Access Compliance Report

Public Rights-of-Way

(Curb Ramps)

Intersection ID: 27895	Main Street: FAIR_ISLE_DR	Cross Street: KILCHURN_CT	Location: SW
ADA ID: 8CA608C0839D	Ramp Type: PerpDiag	Initial Pass/Fail: Fail	Overall Compliance: No
			Severity Score: 72.5
Codes/Mitigation Info/Possible Solution		Field Measurements/Component Compliance

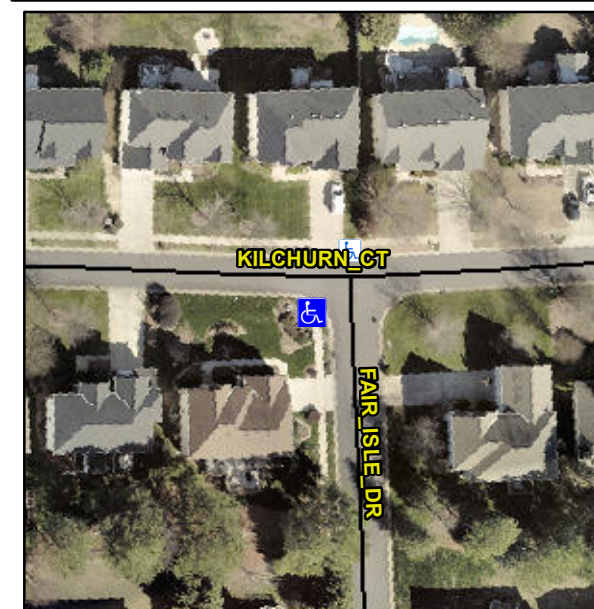
Not Found, R304.5.1, R304.2.2, R304.5.3

Compliance	Description	Data	Compliance	Description	Data
N/A	Ramp Length (in)	96.0	No	Ramp Slope (%)	8.4
No	Ramp Width (in)	25.0	No	Ramp XSlope (%)	8.7
N/A	Flare Type LT	N/A	N/A	Flare Type RT	N/A
N/A	Flare Slope LT (%)	N/A	N/A	Flare Slope RT (%)	N/A
N/A	Flare Traversable LT?	N/A	N/A	Flare Traversable RT?	N/A
N/A	Landing Length (in)	N/A	N/A	DWS Provided?	N/A
N/A	Landing Width (in)	N/A	N/A	DWS Contrast?	N/A
N/A	Landing Slope (%)	N/A	N/A	DWS Length (in)	N/A
N/A	Landing X Slope (%)	N/A	N/A	DWS Full Width?	N/A
N/A	Landing Curb? (Y/N)	N/A	N/A	DWS Offset (in)	N/A
N/A	Shared Landing?	N/A			
N/A	Gutter Ponding?	N/A	N/A	Gutter Slope (%)	N/A
N/A	Gutter Lip Ht (in)	N/A	N/A	Gutter X Slope (%)	N/A
N/A	Painted X Walk1?	No	N/A	Painted X Walk2?	No
	X Walk 1 Direction	To SE		X Walk 2 Direction	To NE
N/A	X Walk 1 Width (in)	N/A	N/A	X Walk 2 Width (in)	N/A
	X Walk 1 Slope (%)	1.3		X Walk 2 Slope (%)	1.1
	X Walk 1 X Slope (%)	2.7		X Walk 2 X Slope (%)	3.8

Remove & Replace Curb Ramp With Two New Directional Ramps or Equivalent.
